Subject: **OSCILLATION IN HIGH TEMPERATURES**

Model: **BVM-14E1U, BVM-14E5U, BVM-14F1U**
BVM-14F5U, BVM-20E1U, BVM-20F1U

Serial No: **2,000,001 AND HIGHER**

Figure 1

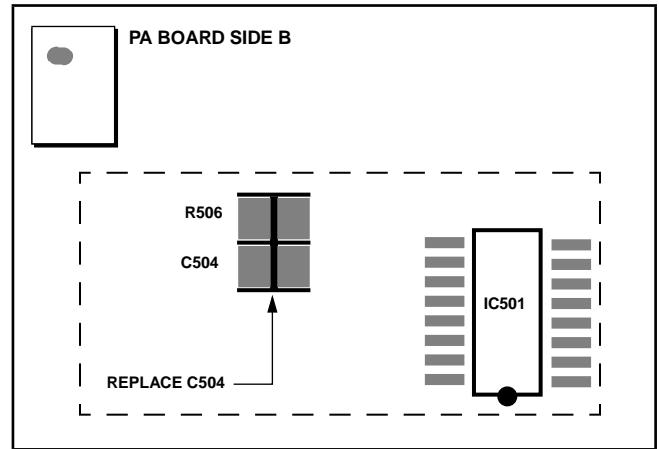
When units are operated in high temperature environments, such as rack-mounted, horizontal noise may occur if unit becomes too hot. Replace capacitor C504 on the PA board, side B with improved one.

Part No.	Description	Qty.
1-164-690-11	Capacitor, 2200pF	1
